## **Board of County Commissioners Summary Report**

**Case name:** **PM22-006**  
**Arcadia Creek**

RE: Arcadia Creek – Variance Requests to the Private Access

Re: Revised Variance Request Arcadia Creek  
Technical Review Committee

DETENTION VARIANCE EXHIBIT

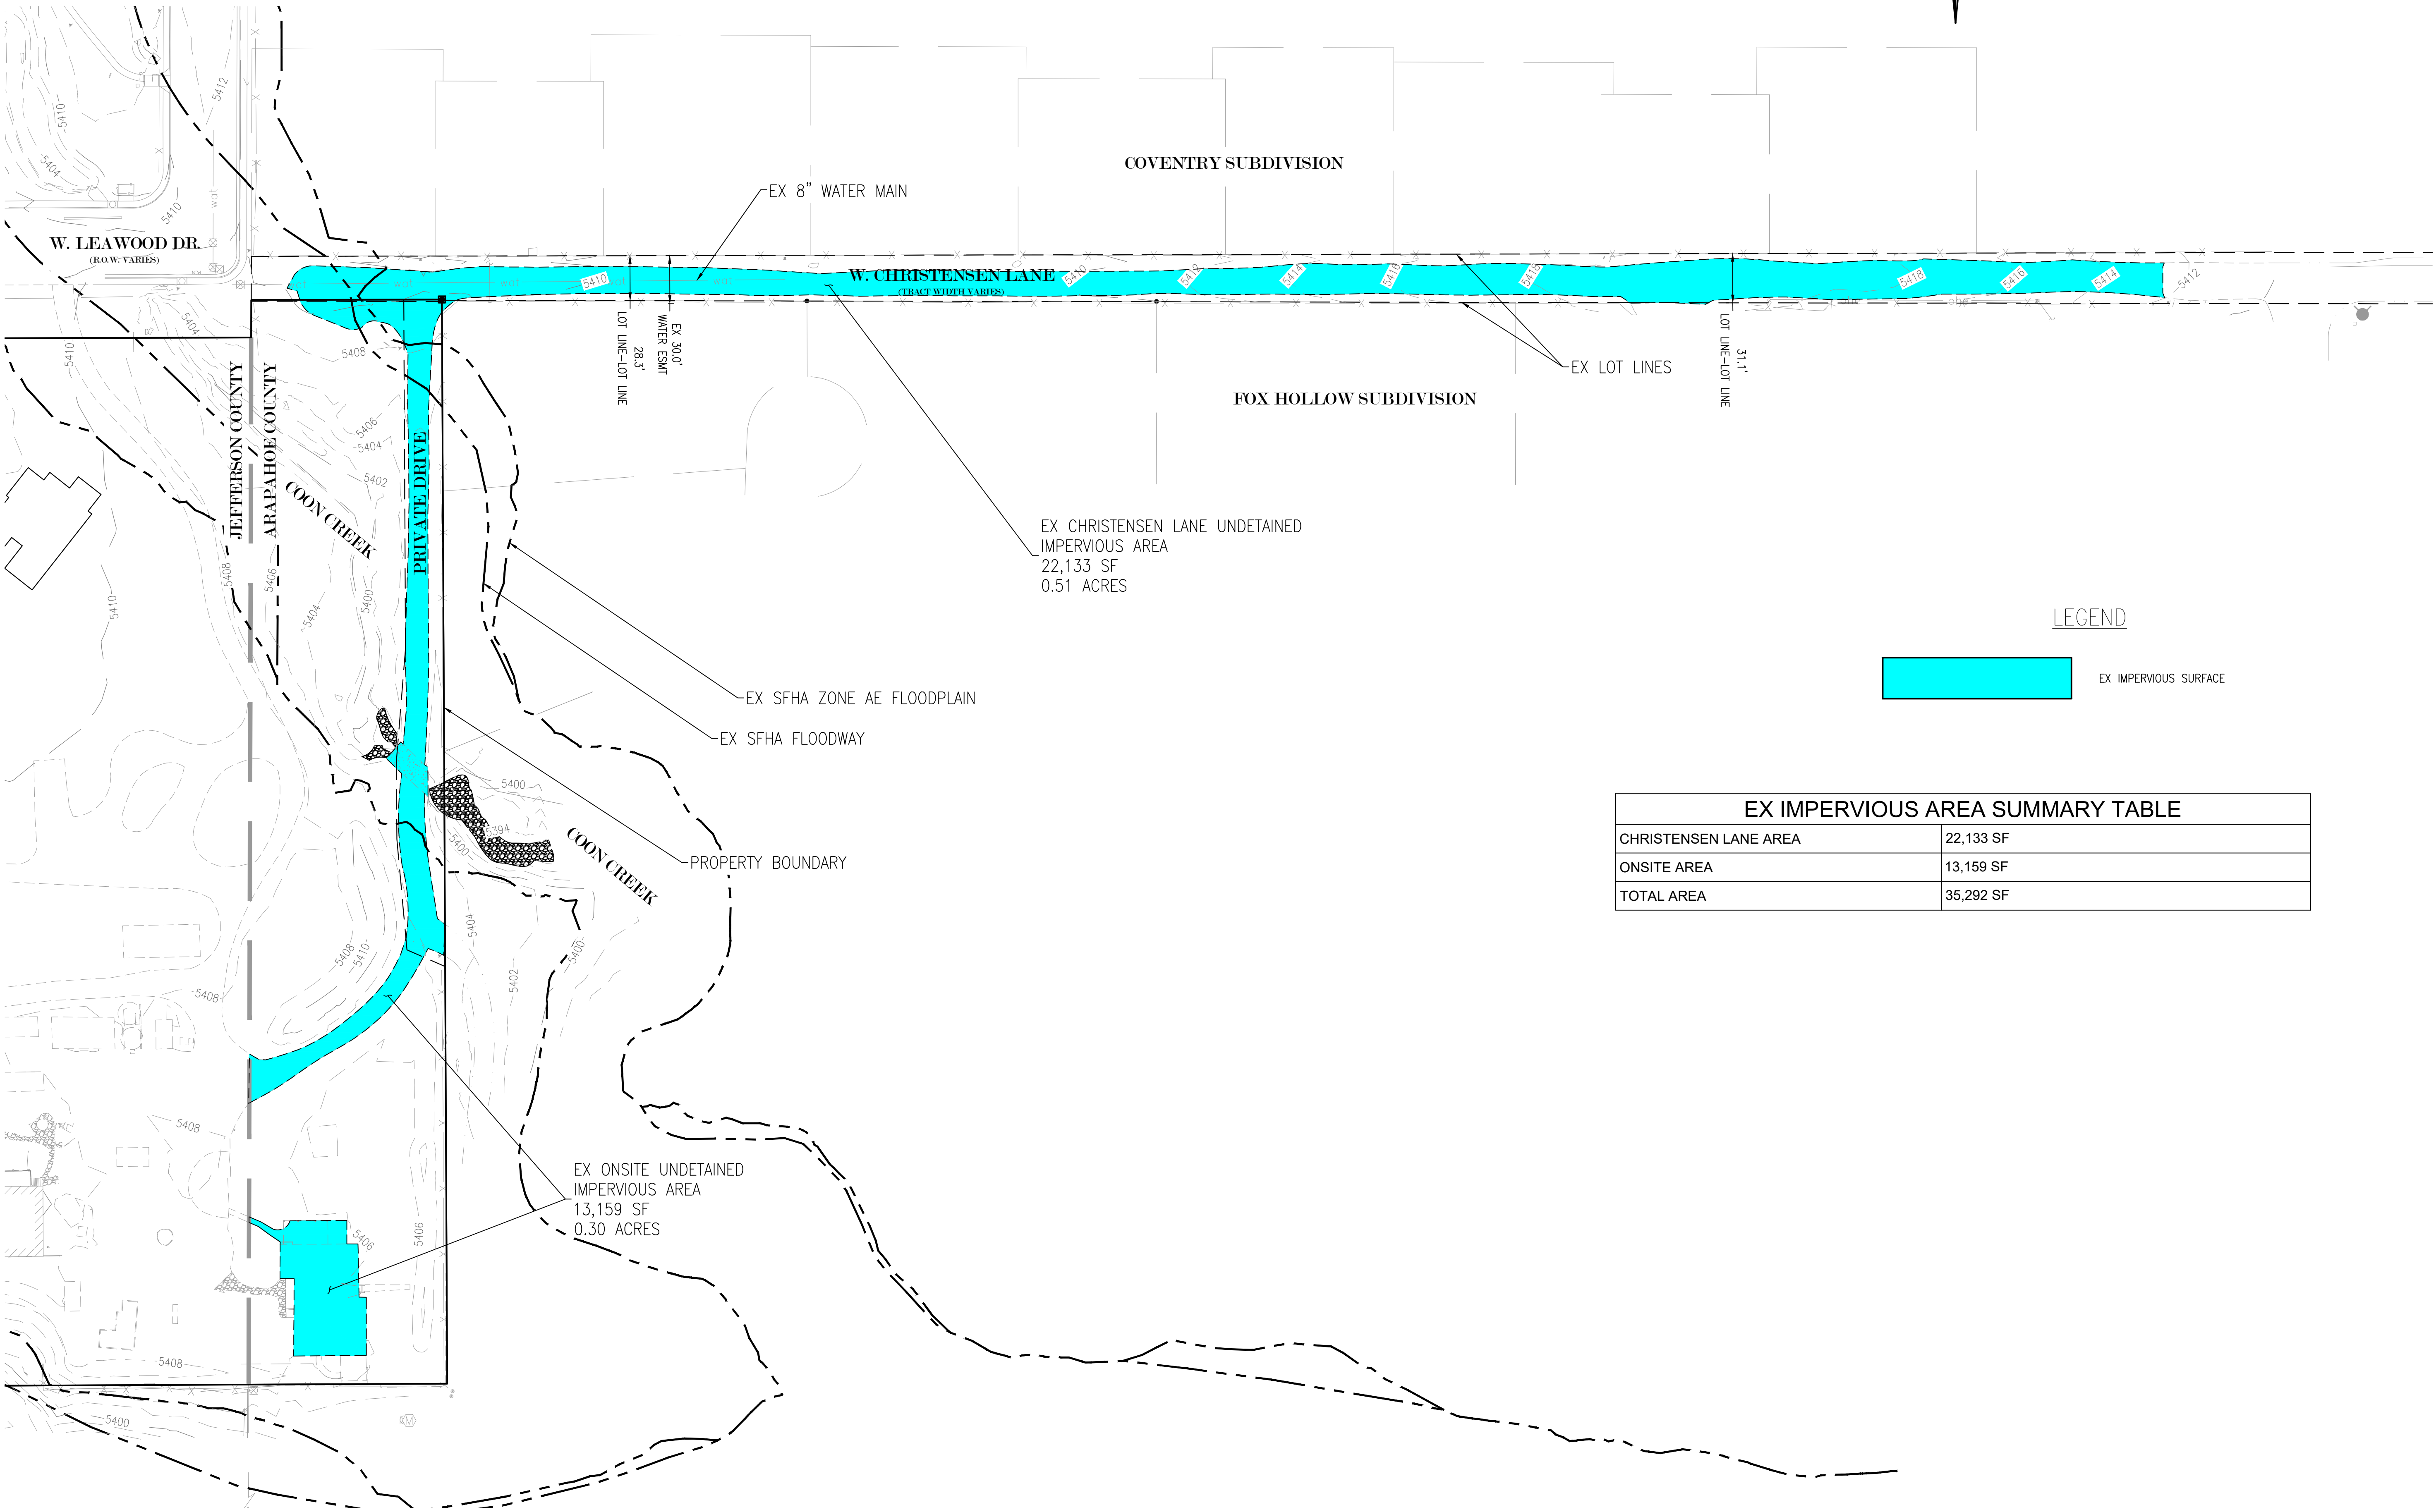
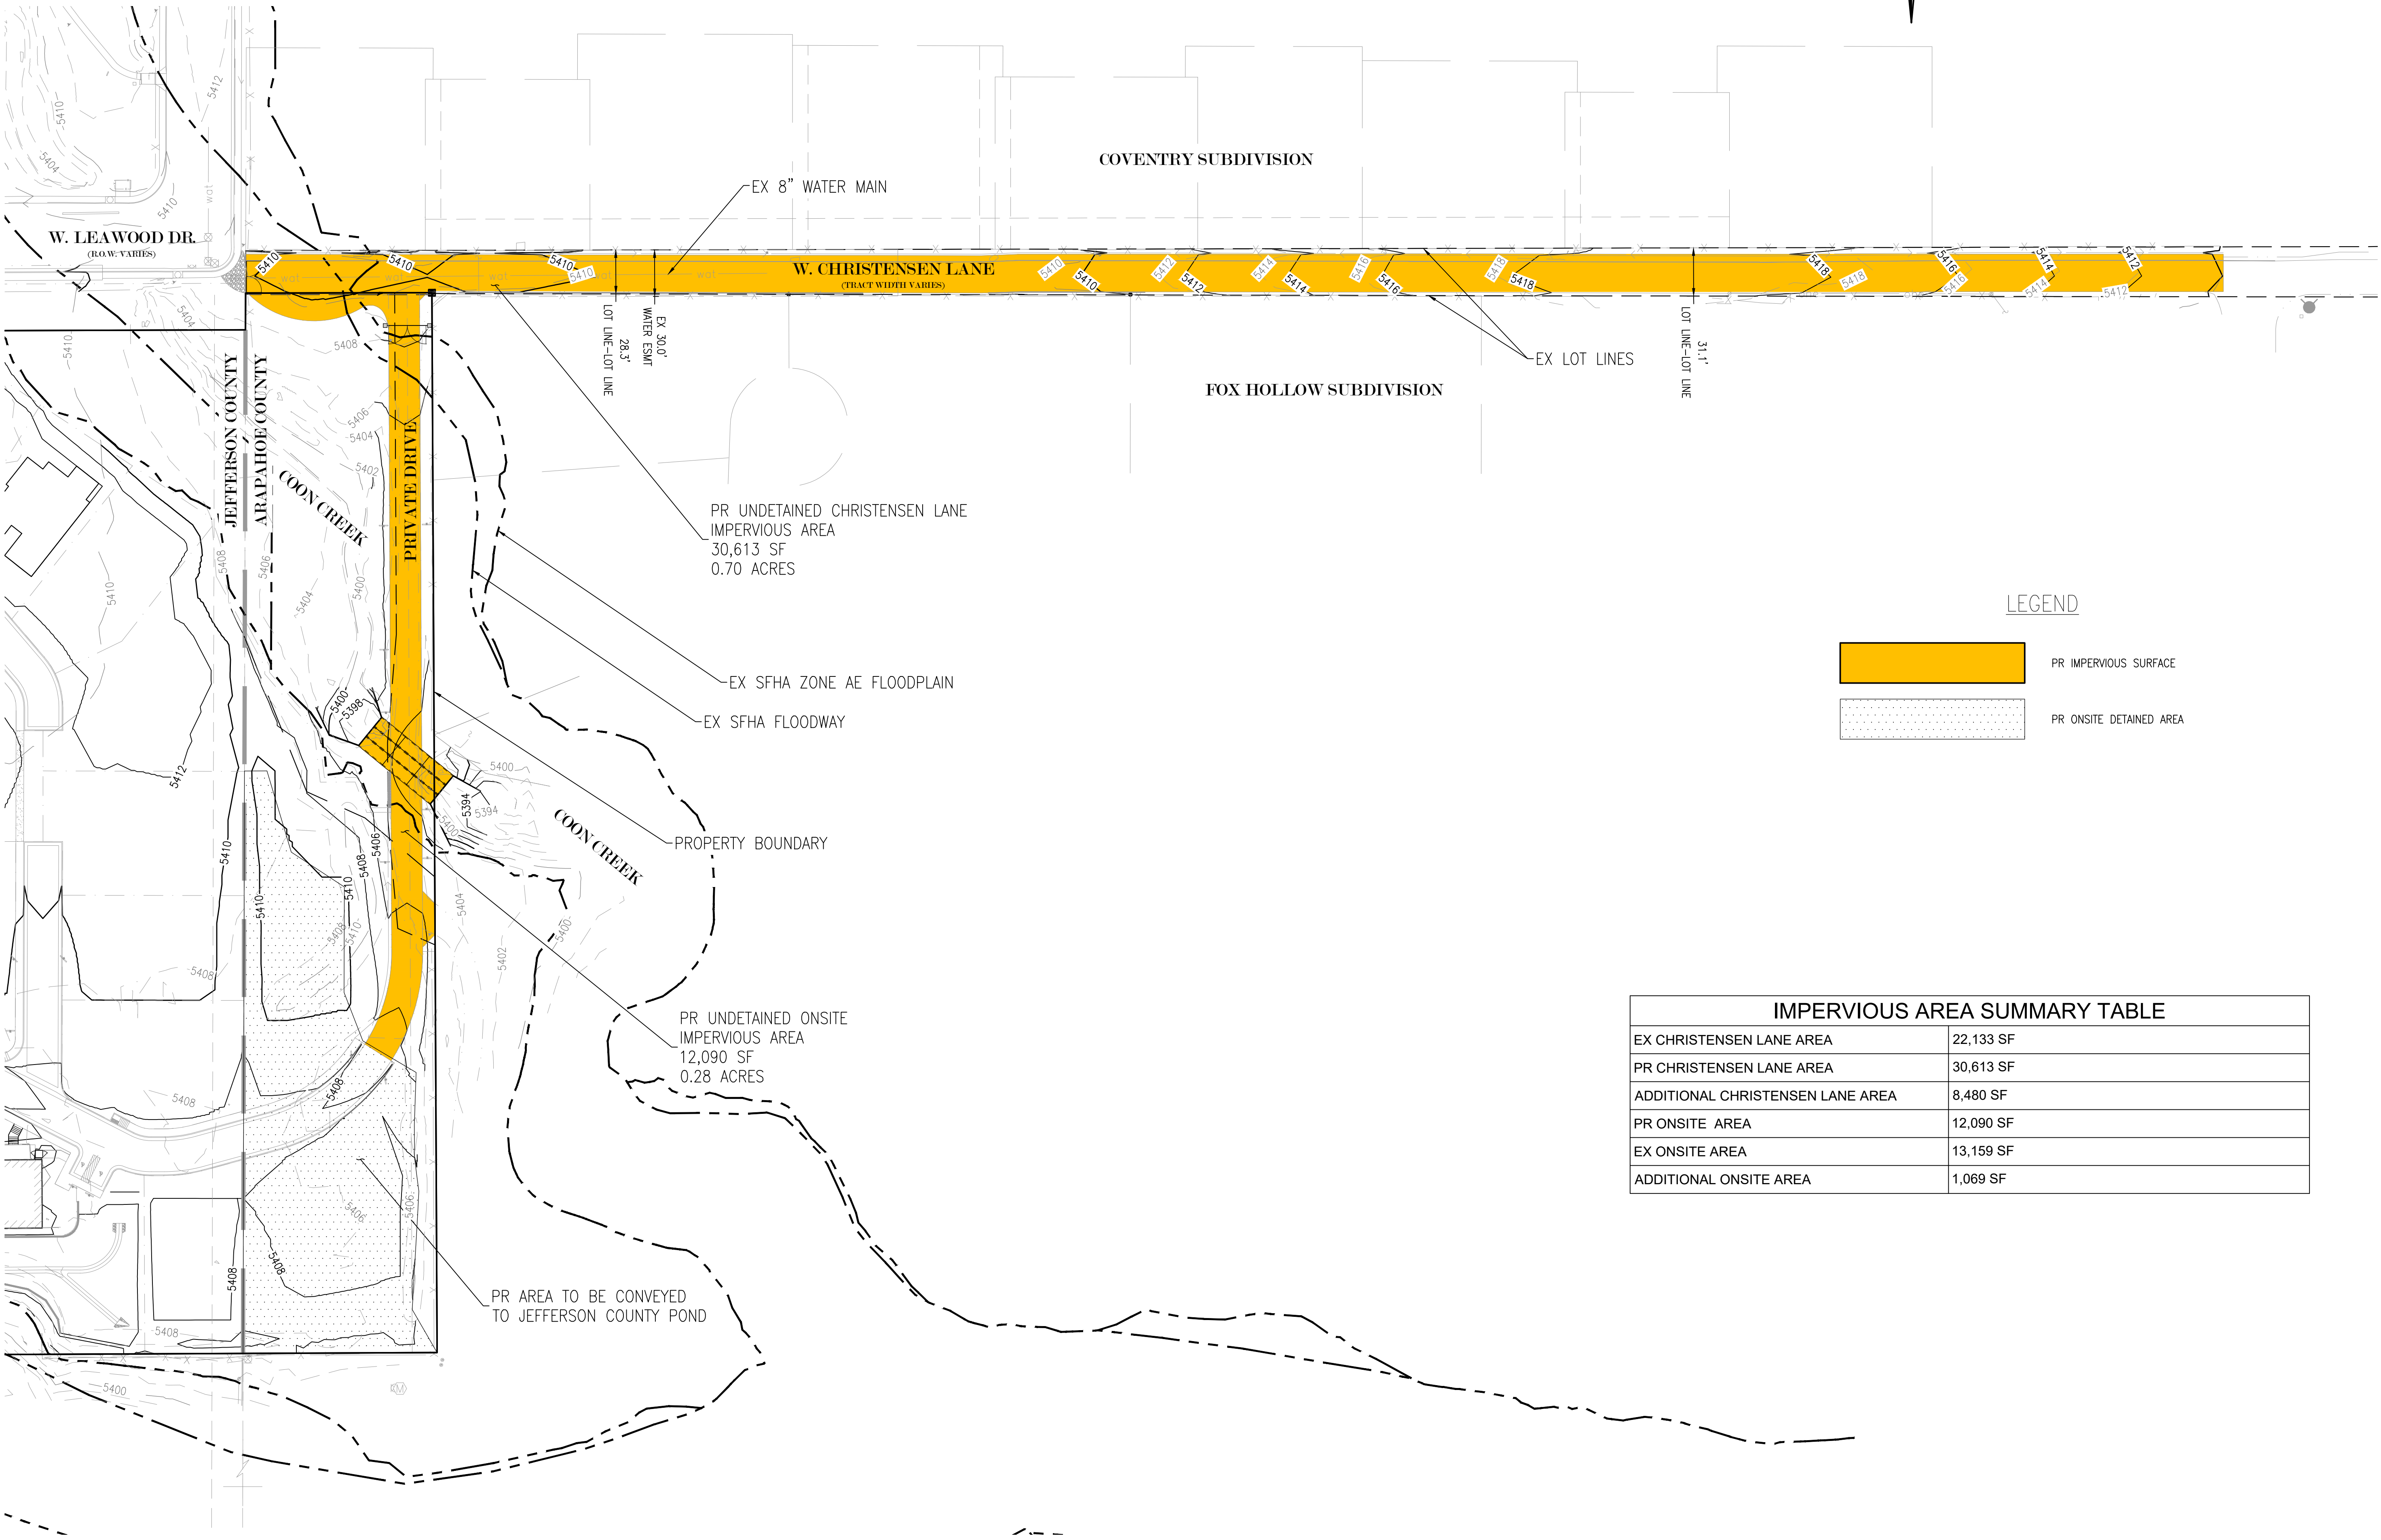
The purpose of this letter is to request a variance from Arapahoe County Stormwater Management Manual (ACSM) Section 13.1.1 which mandates on-site detention (flood control) be provided for the development at Lot 1, Block 30, Leawood Subdivision Filing No. 5 (Site). This letter shall detail the variance per requirements stated in ACSM Section 1.9.1.

To preface, the applicant is providing full-spectrum detention (water quality and flood control) for a large portion of the subject property. Specifically, the southern portion of the site which has means to be captured and transported to a pond within the Jefferson County parcel. This variance request pertains to the northern half of the subject parcel, and the common ownership tract of Christensen Lane. Due to topography, floodplain, and lack of existing infrastructure, it is not feasible to provide detention for these areas.

- Pre-development impervious area = 22,133-sf
- Post-development impervious area = 30,613-sf
- Delta = 8,480-sf of impervious area added with widening of the lane

- Detention ponds must discharge at or above the 100-year base flood elevation of the adjacent tributaries. This requirement is to ensure proper hydraulic function of a detention pond when flooding of the tributary occurs. To meet these criteria, a proposed pond must have a minimum invert elevation (pond bottom) of 5409, as illustrated on Sheet 31 of the FHAD for Dutch Creek, Coon Creek, Lilley Gulch, and Three Lakes Tributary prepared by Mile High Flood District. If enough area were provided onsite to construct a pond, existing topography would prevent the required elevations from being met. Topography would not allow the capture and transport of runoff from the lane into a detention pond at the required invert elevation.

The applicant shall provide detention per Section 13.1 .1 of the Arapahoe SMM to the extent physically possible. These areas include the two single family dwellings and associated private drive, the southern portion of the subject property. See attached exhibit for clarification.

The applicant shall remove and replace existing inlets along Christensen Lane, supporting a more robust drainage conveyance system. The existing storm sewer within Christensen Lane shall be cleaned of debris to help facilitate the transport of runoff to Coon Creek. The existing outlet into Coon Creek shall be repaired and sediment removed. The outlet pipe shall be retrofitted with updated erosion control measures including rip rap and energy dissipation.
